**MUSGROVE
ENGINEERING, P.A.**

Re: **Renovate Infrastructure
Capitol Annex Phase 4
Department of Administration
Boise, Idaho
DPW Project No. 14006**

Addendum No. 2

SHEET A9.2

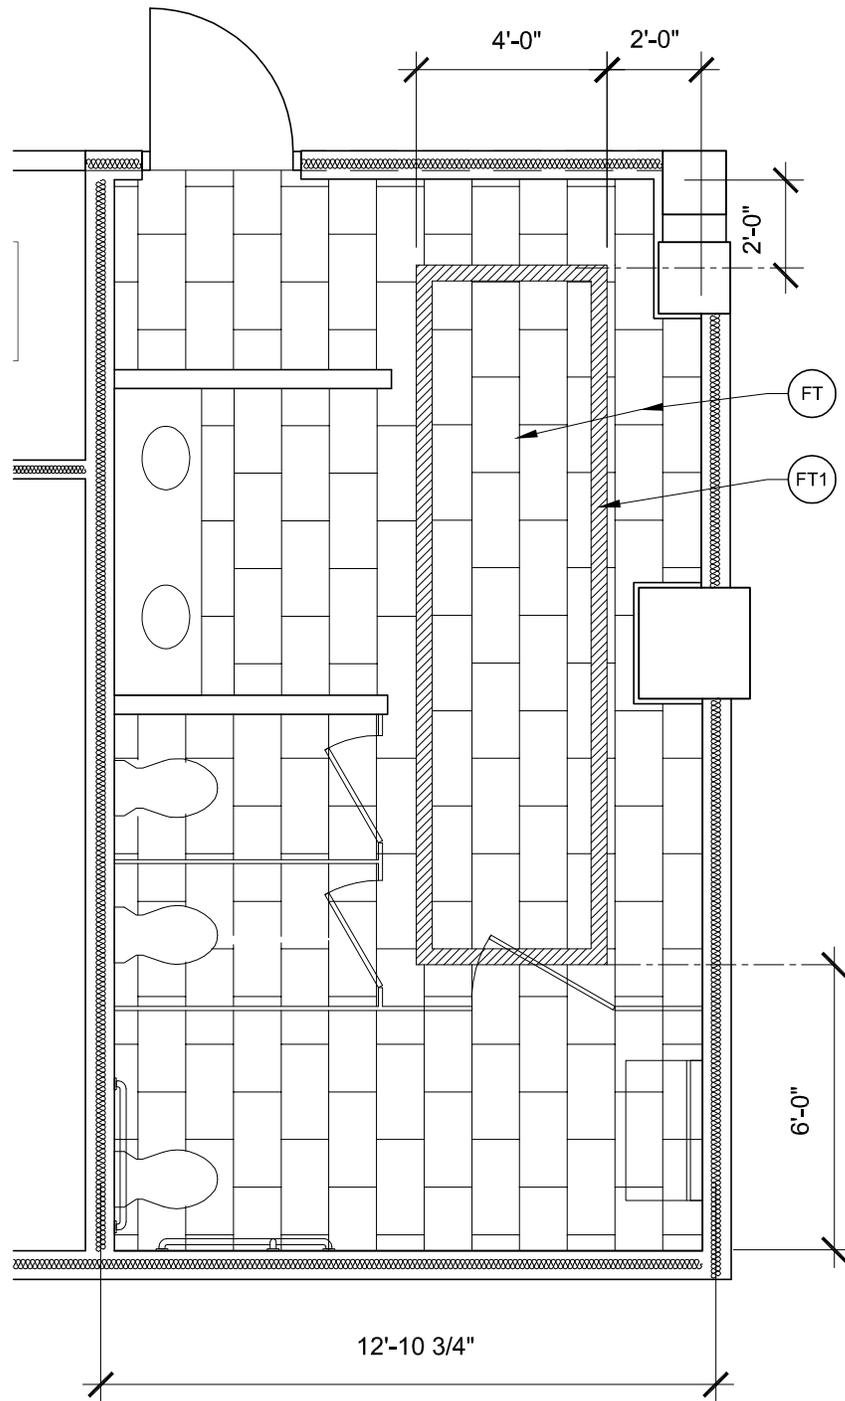
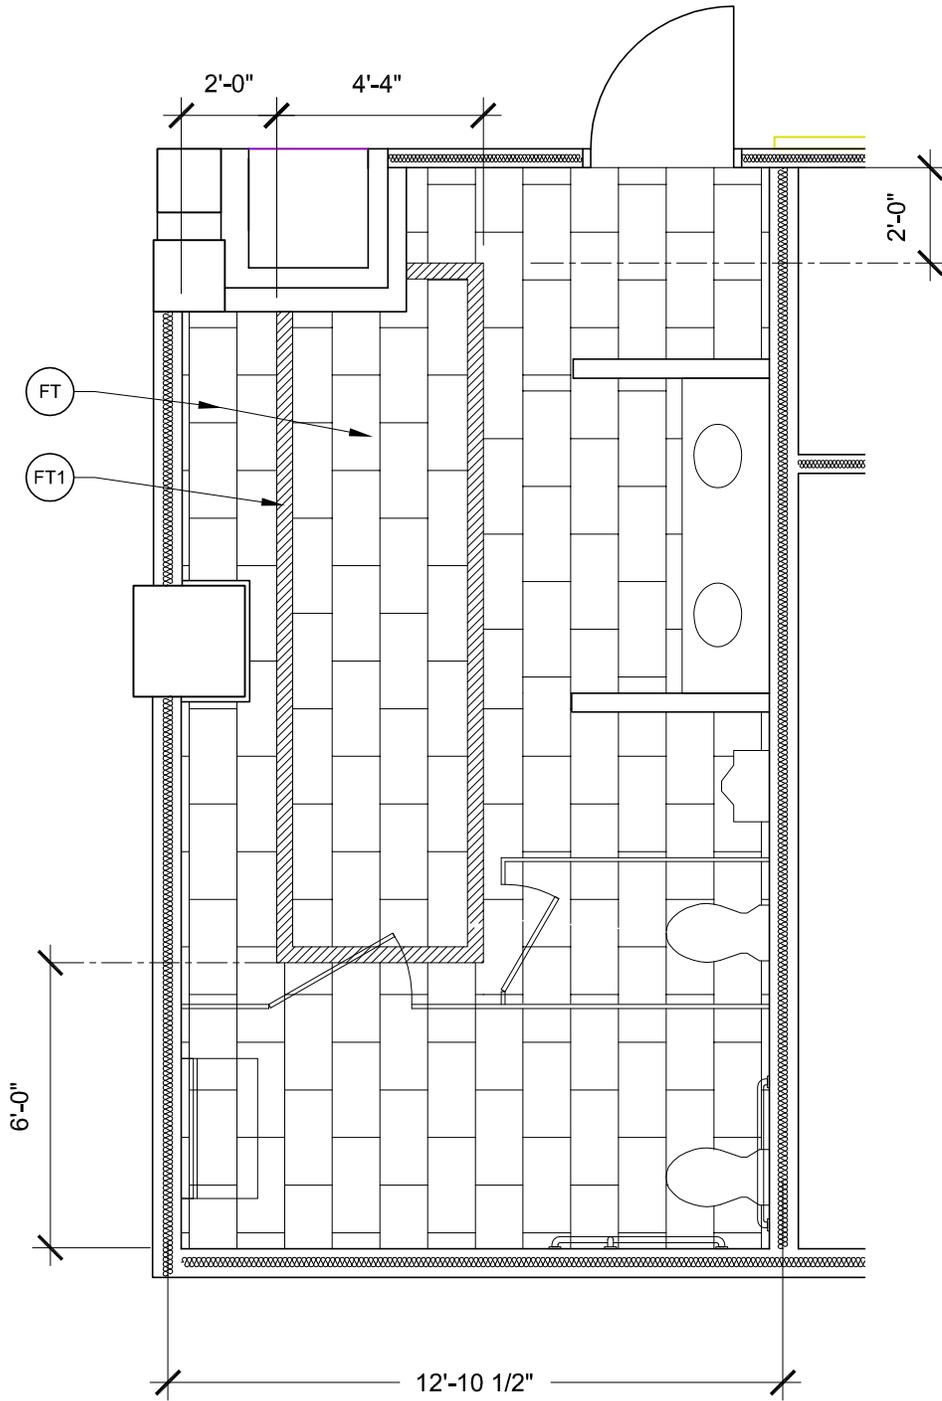
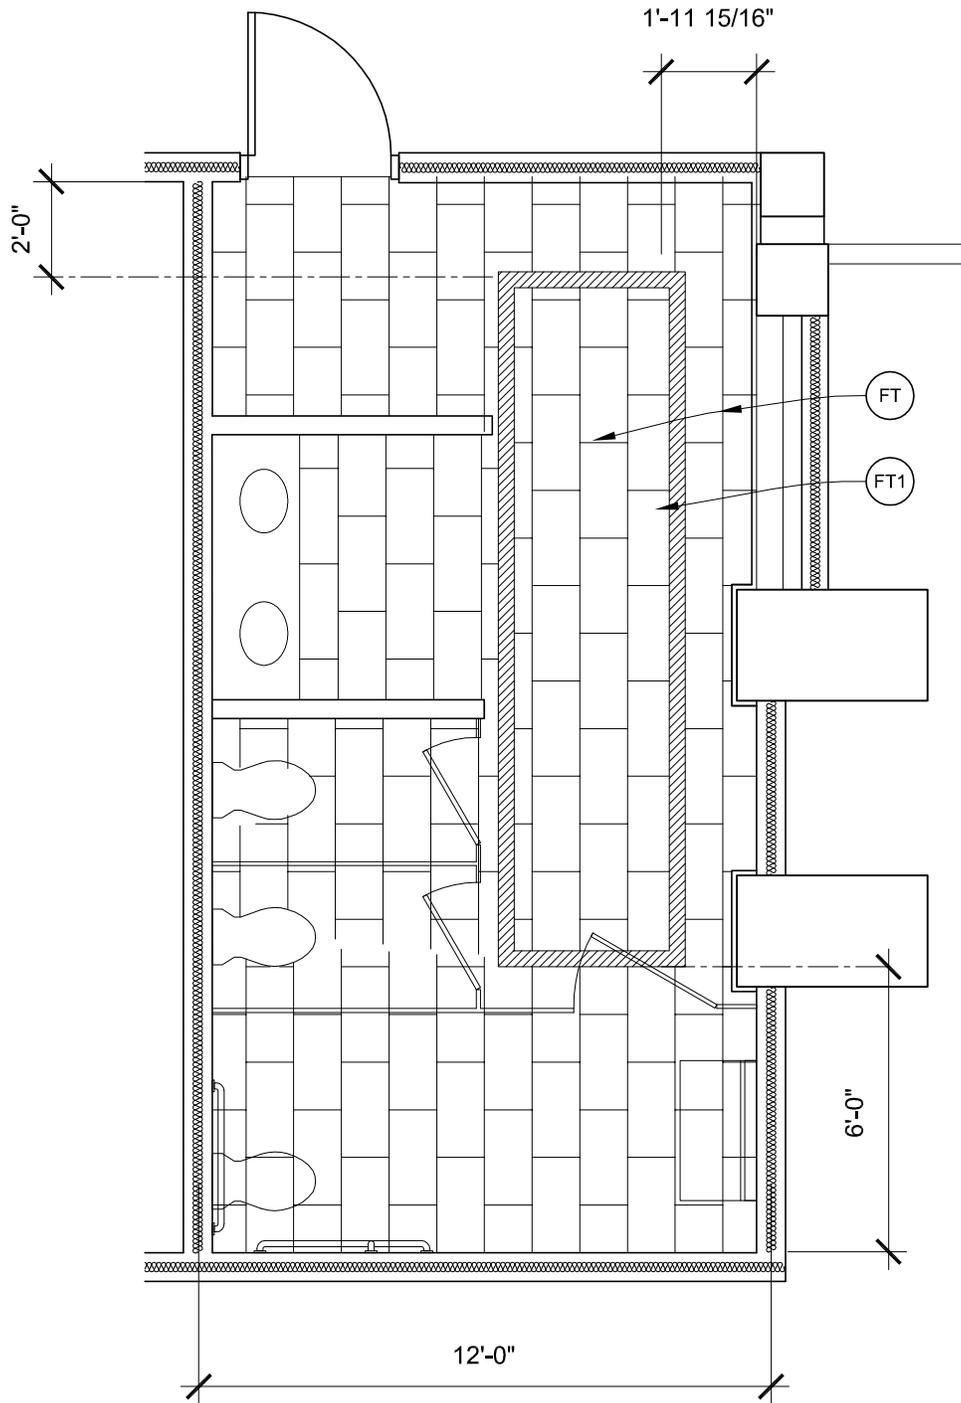
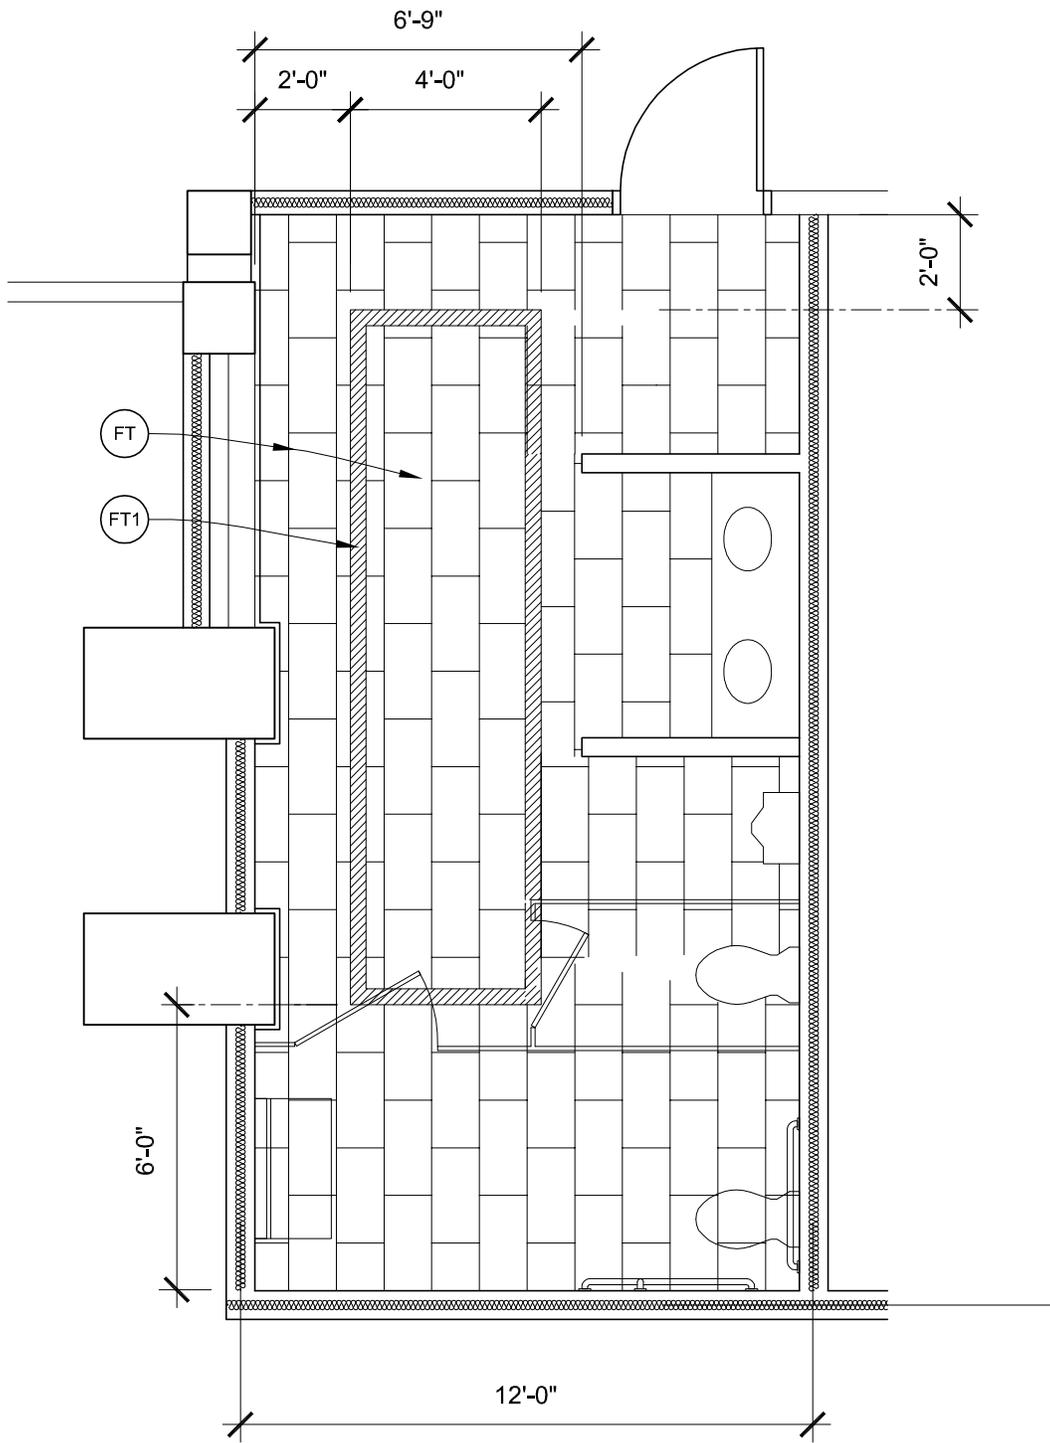
1. At flooring plans, revise flooring patterns per Drawings ADD-2-1, ADD-2-2, ADD-2-3 and ADD-2-4, attached to this addendum.

ADD-2-6

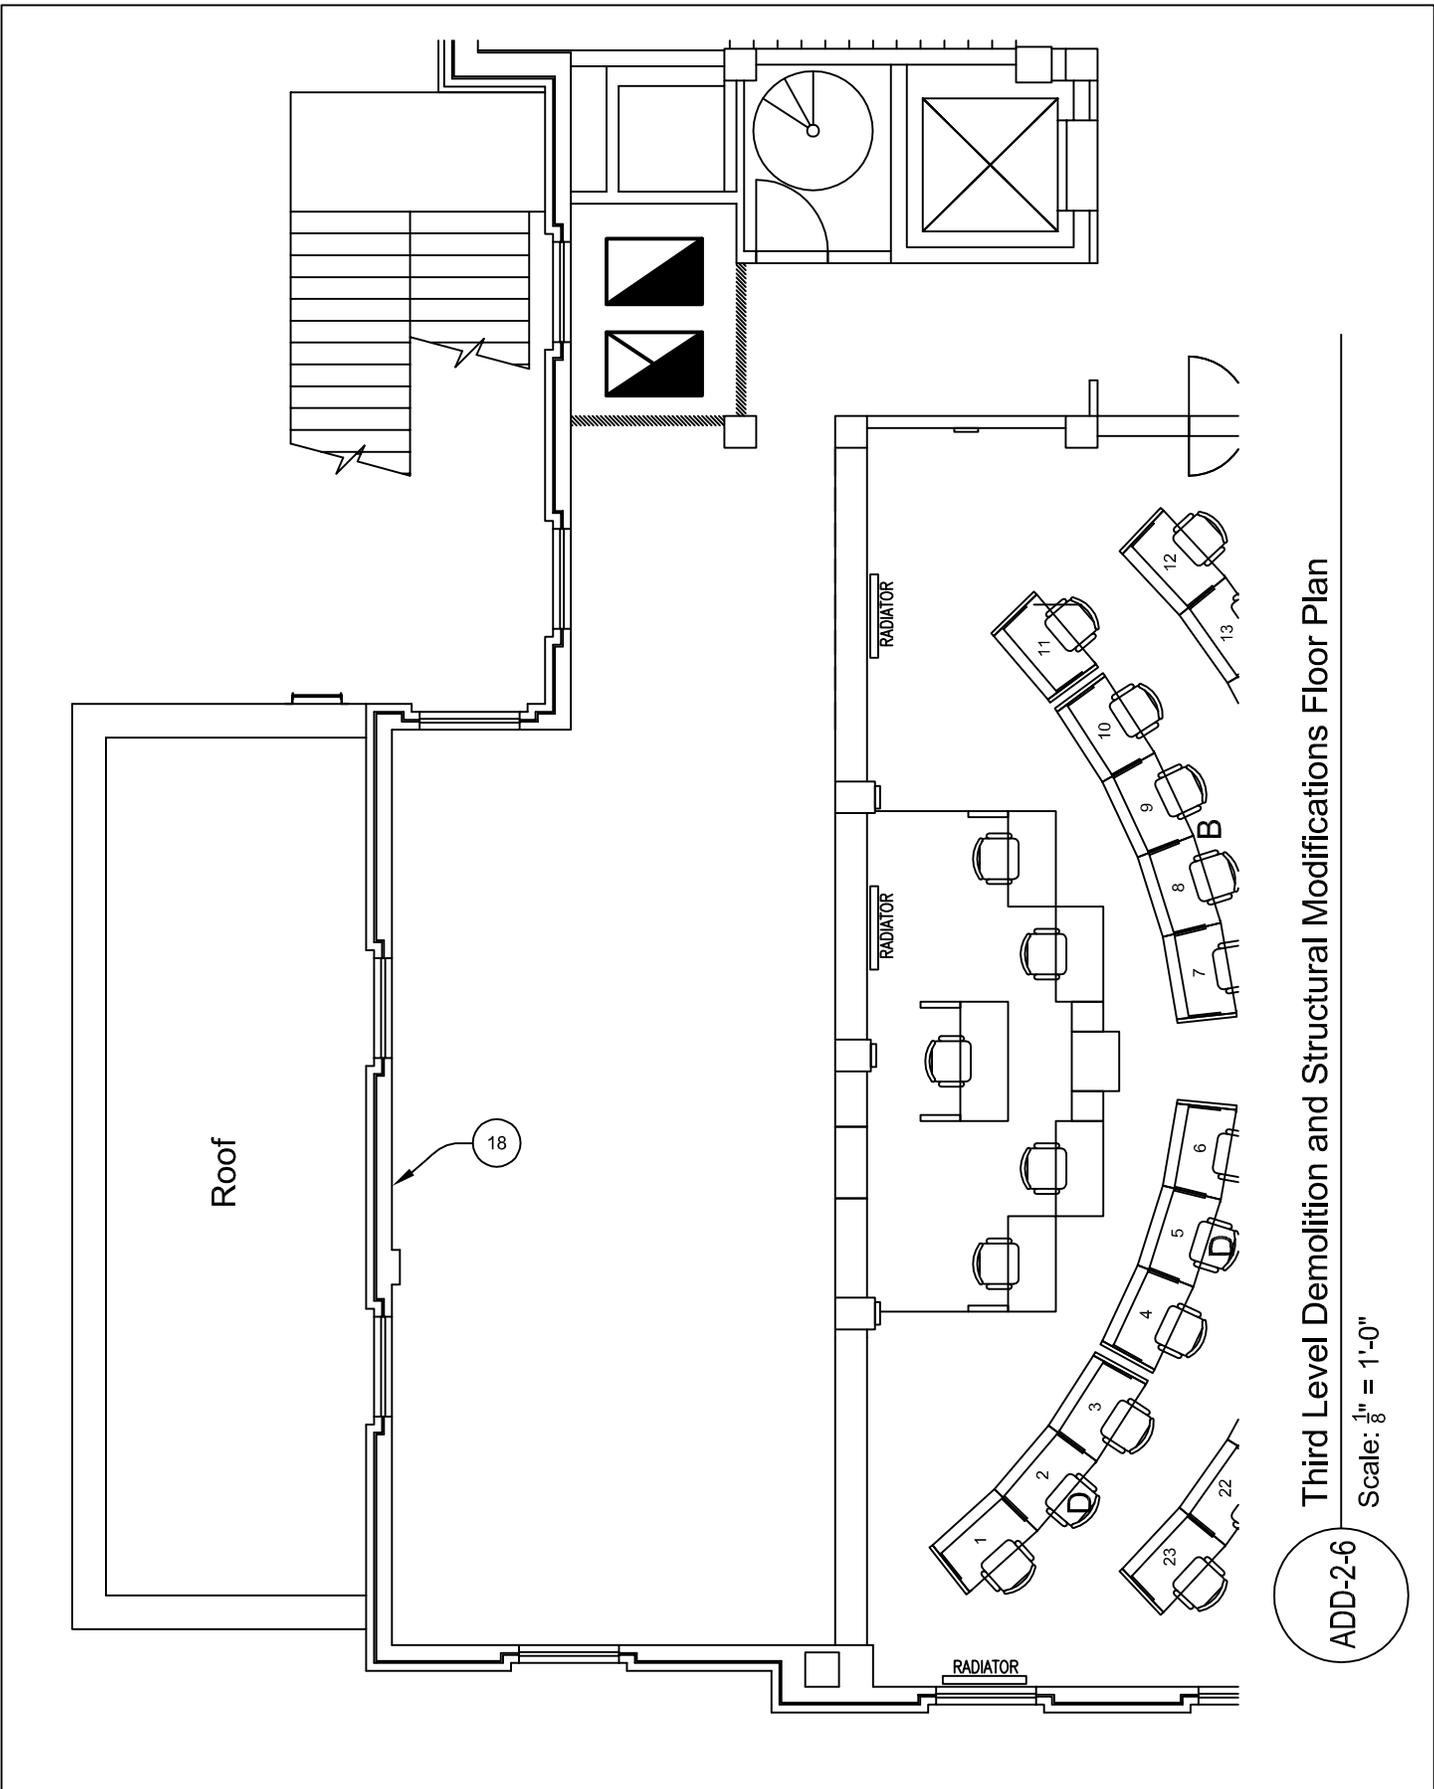
1. On floor plan, at north side of building, second window from the east, keyed note 18. This window infill is brick.
2. On floor plan at south center location of building additional doors and walls to be removed. On floor plan, at south center location there is a window at this location. Infill will need removed and new window provided. Refer to Drawing ADD-2-5, attached to this addendum.
3. On floor plan, at north side of building, there should be (3) windows at northeast wing. Infill shall be removed and new window provided. Refer to Drawing

ADD-2-6, attached to this Addendum.

ADD-2-7

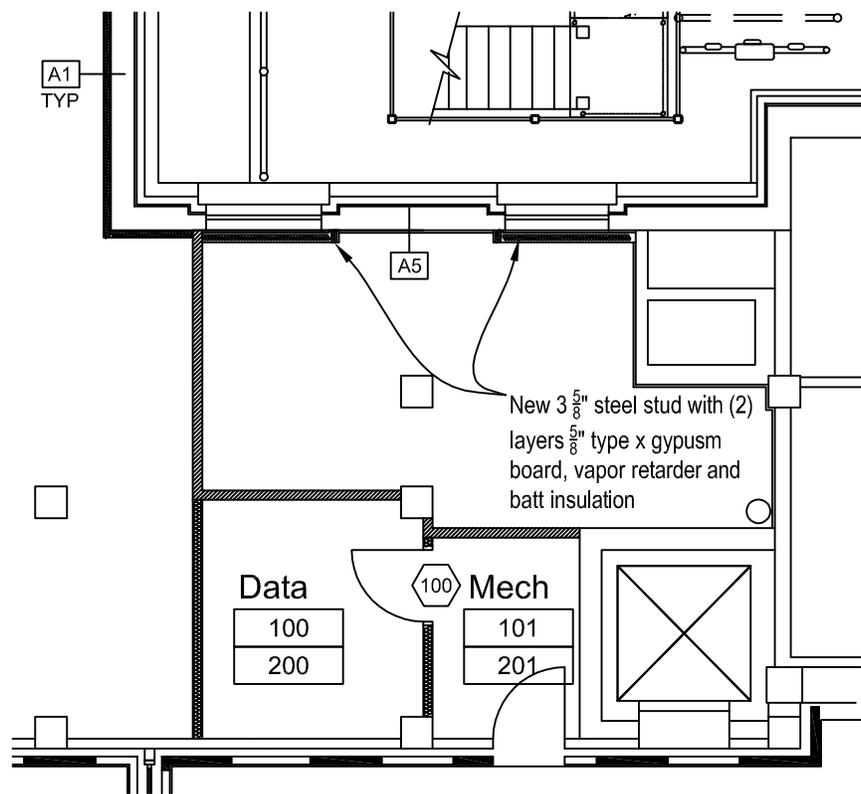
1. At floor plans in northeast section of building by elevator revise per Drawing ADD-2-7, attached to this addendum.

ADD-2-8

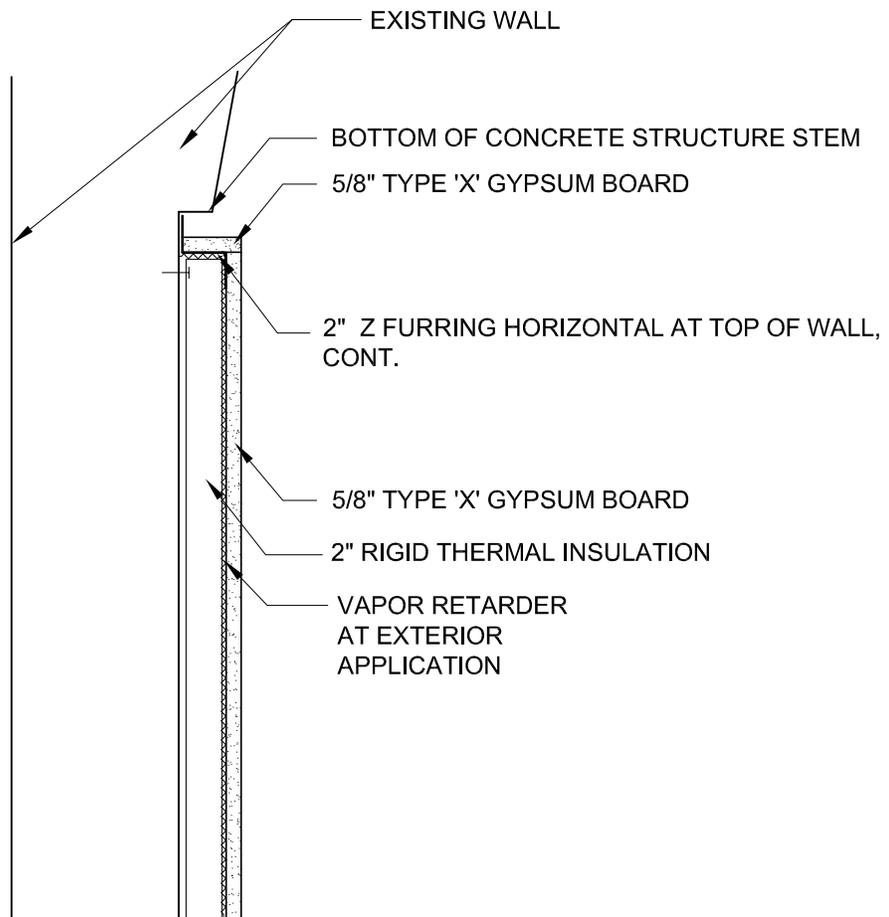
1. At details 12 and 13, revise WPT to PTW, Pressure Treated Wood.
2. Provide additional detail for the exterior wall furring at the top track. Refer to ADD-2-8, attached to this addendum.
